# Intel® 82571EB/82572EI Ethernet Controller

Specification Update

*July 2010*  
*Revision 6.3*

**322206US**

## 26. Firmware Reset Occurs when Performing Transactions with a Low Interpacket Gap (IPG) Using Fast Management Link (FML) at 8MHz.

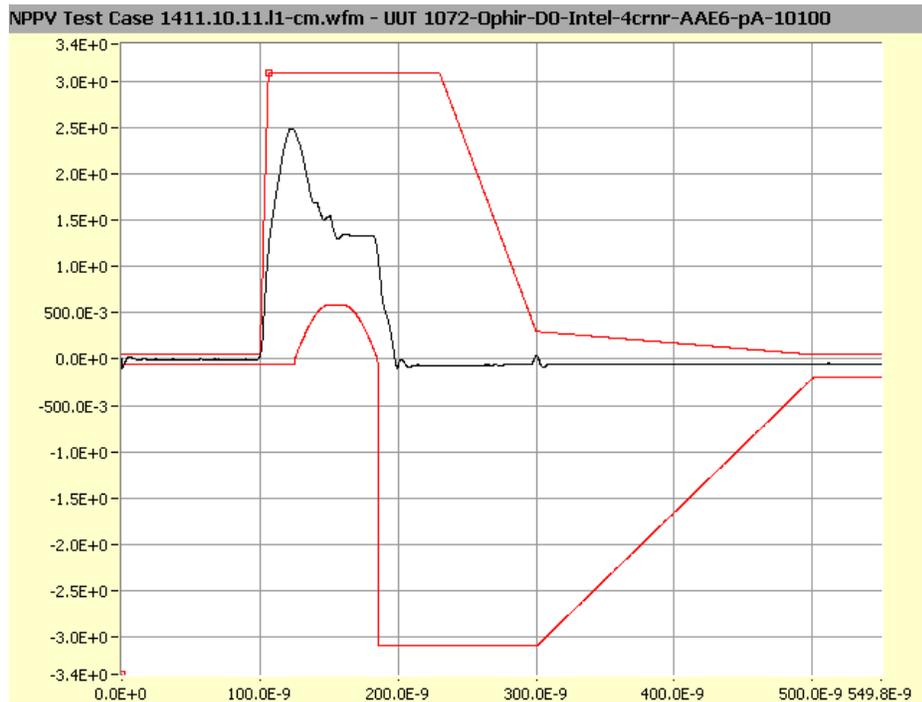
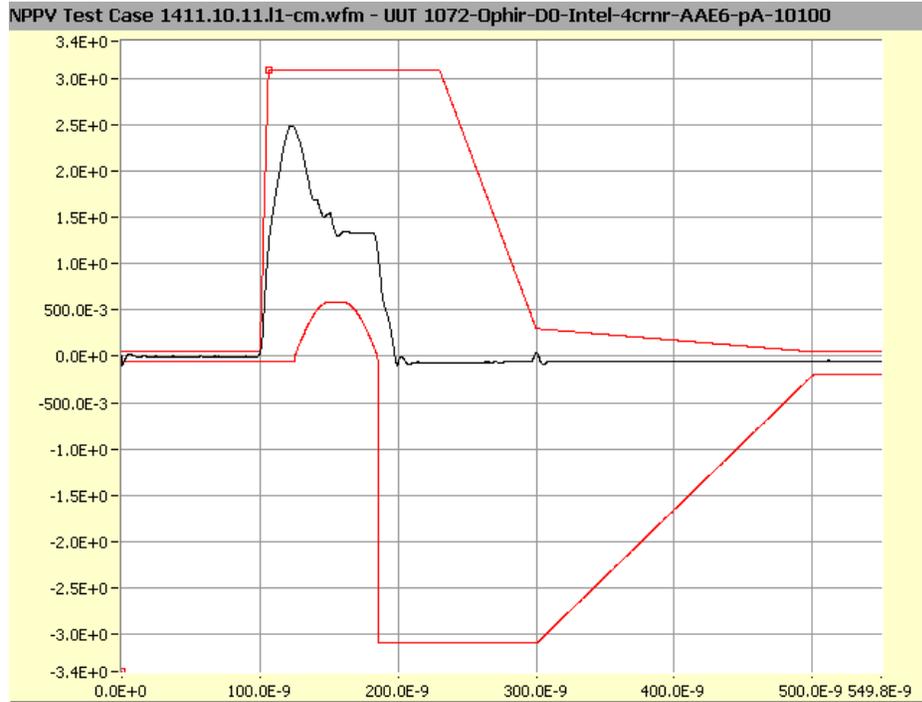
**Problem:** A single firmware reset occurs when FML 8MHz transactions are delivered with an Inter-Packet-Gap (IPG) smaller than 20uSec. Due to speed and memory limitations, buffers of BMC frames being arranged into Ethernet packets are incorrectly released. As a result, a memory error (Null pointer exception) occurs.

**Implication:** Performance impact. The BMC must retry the corrupted transaction.

**Workaround:** The BMC should not transmit with an IPG lower than 30usec.
